VILLAGE OF ROYAL PALM BEACH, FLORIDA

PROJECT NAME: **FPL PATHWAY LIGHTING**
PROJECT NUMBER: **EN1901**

ADDENDUM NUMBER : FIVE

DATE OF ISSUANCE: February 18, 2021

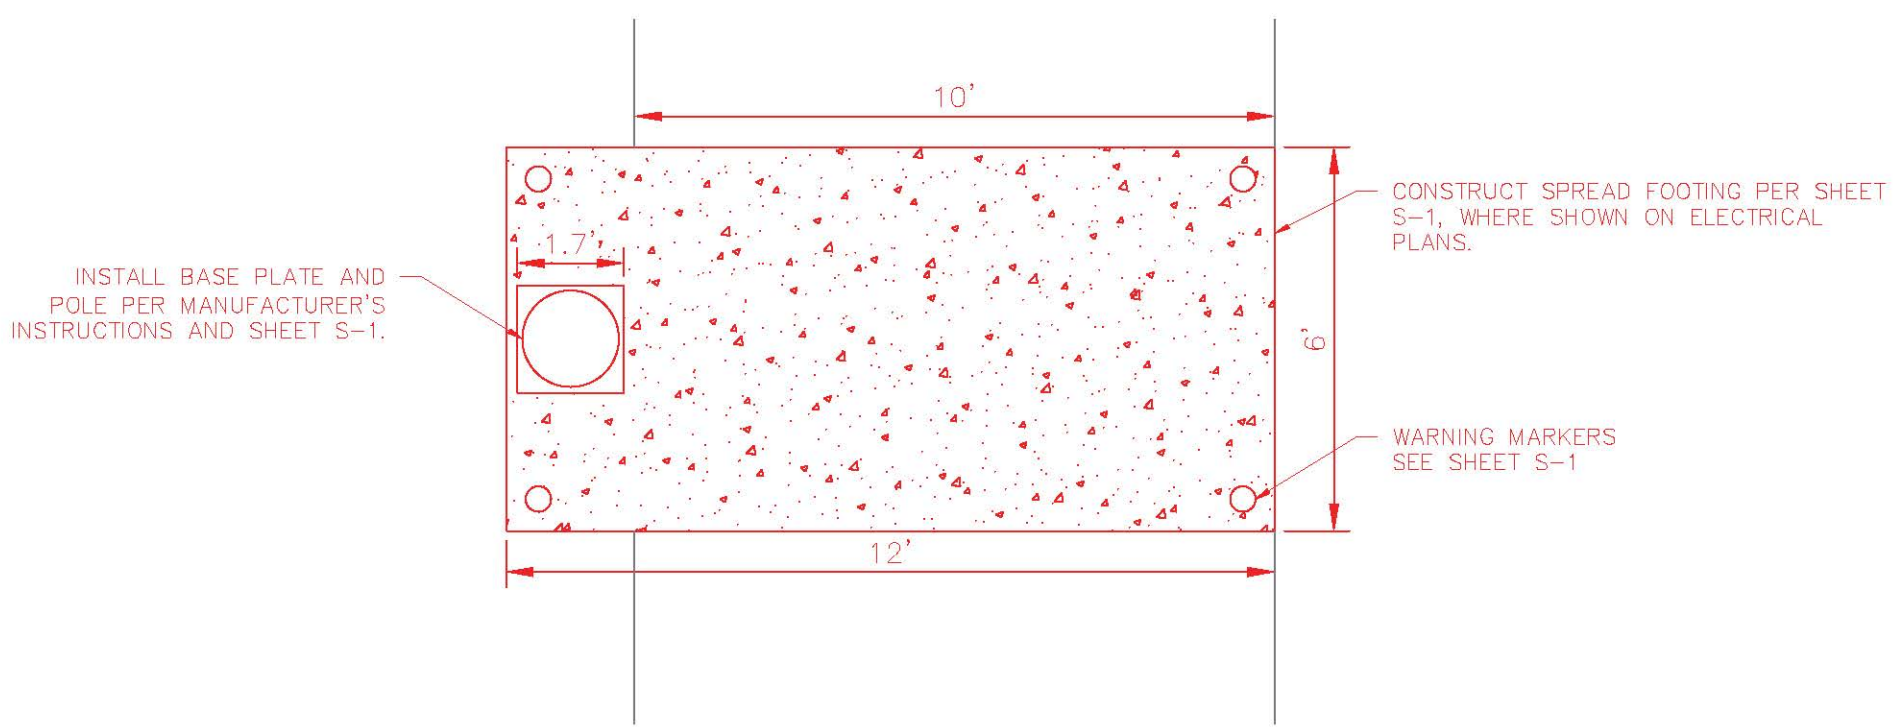
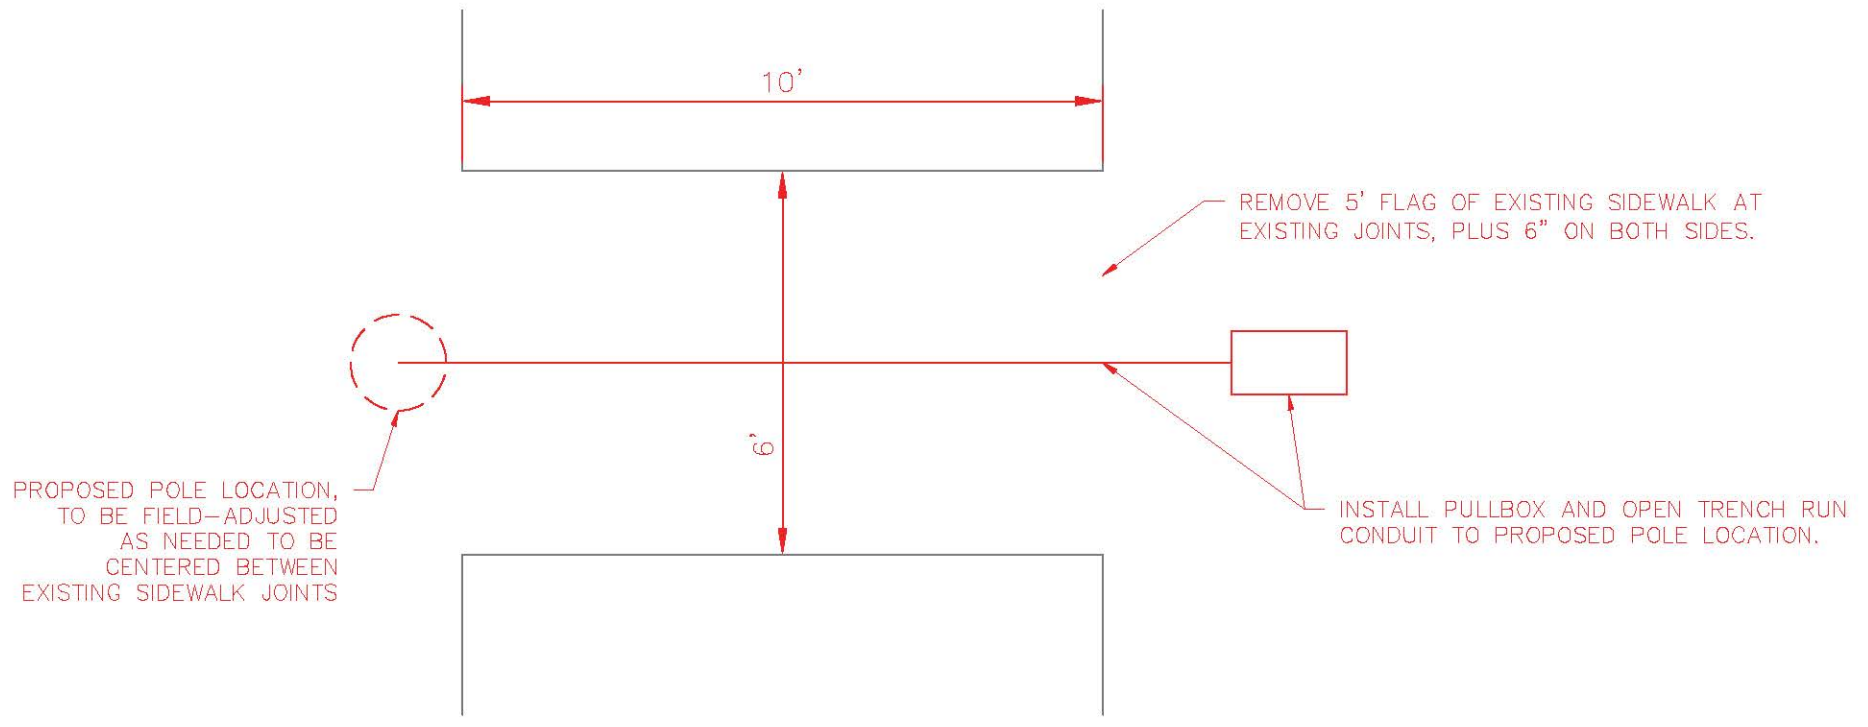
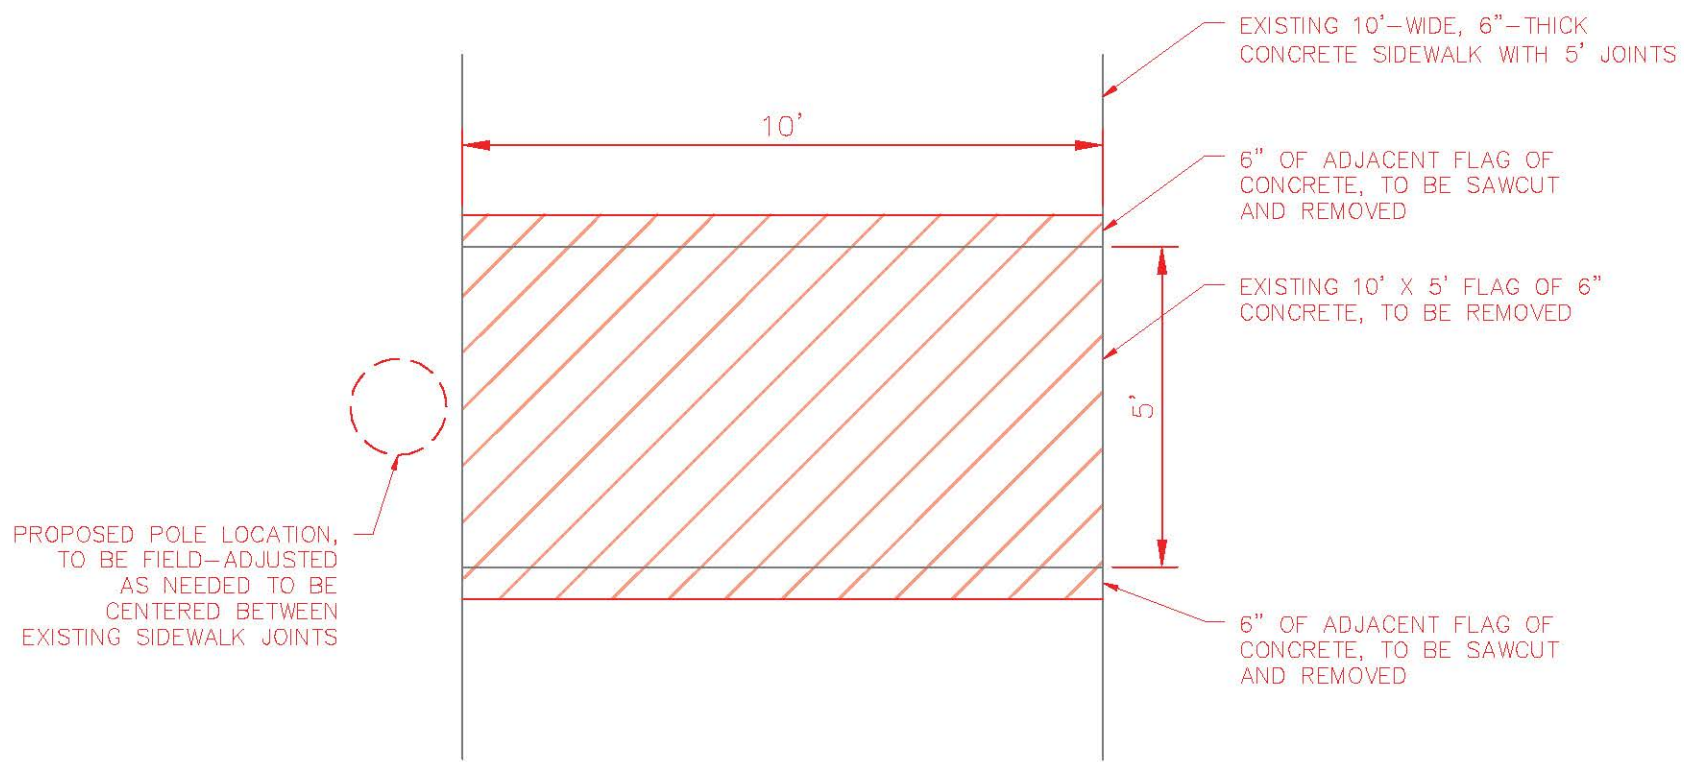
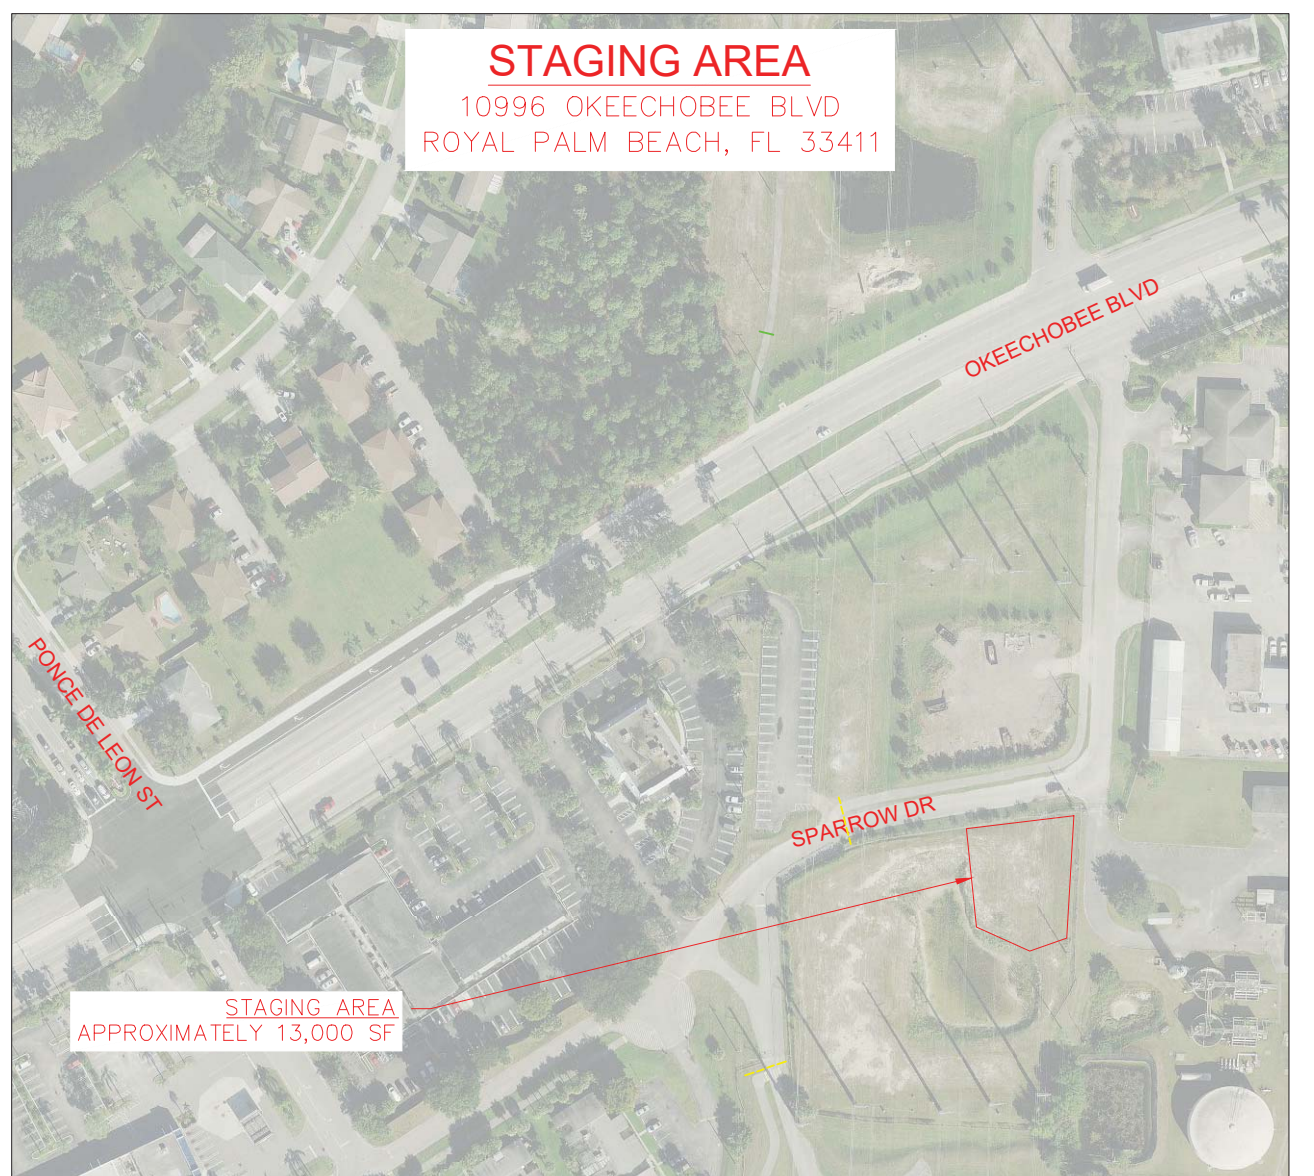
- iv. E-0 through E-4, E-6: Add notes and update drawings to reflect the addition of replacing existing 25' Poles.
 1. Please note on Sheet E-6 that the 18' assembly detail has the pole height corrected to 16', rather than 13'-11".

ELECTRICAL PULL BOX DETAIL
N.T.S.

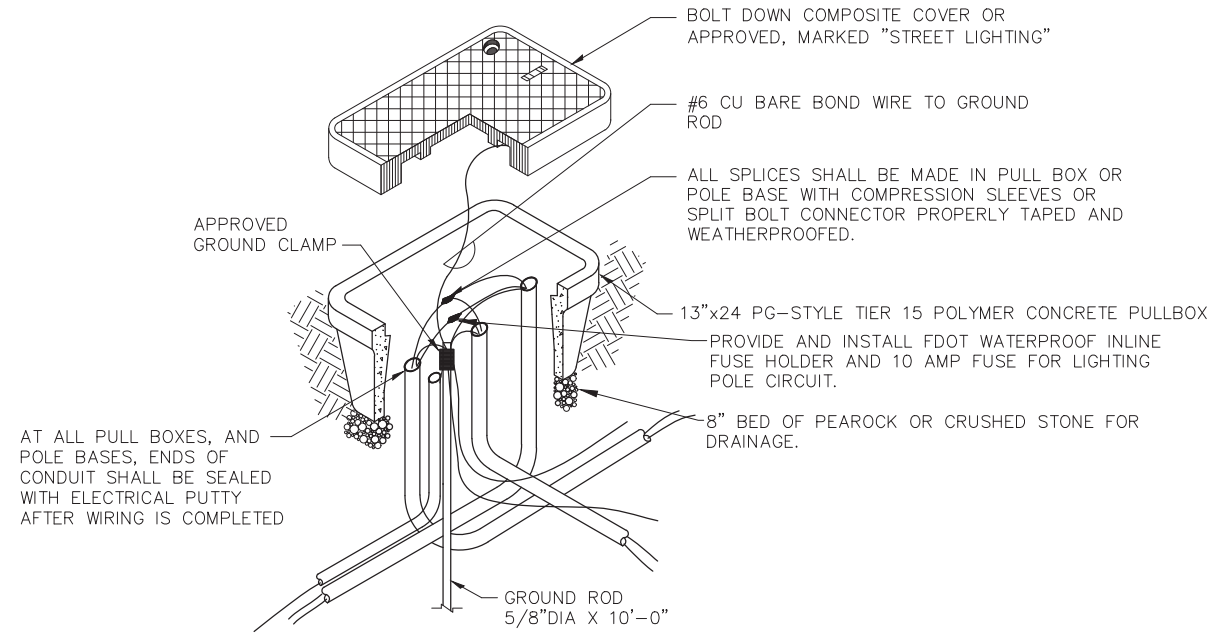
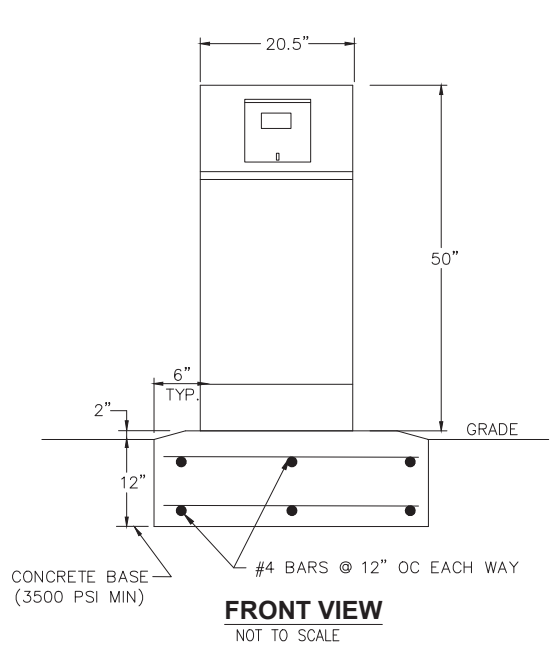
- v. E-9: Pullbox specs updated and canal section added to directional bore detail.
 - b. Add sheet 10: Spread Footer Installation Details
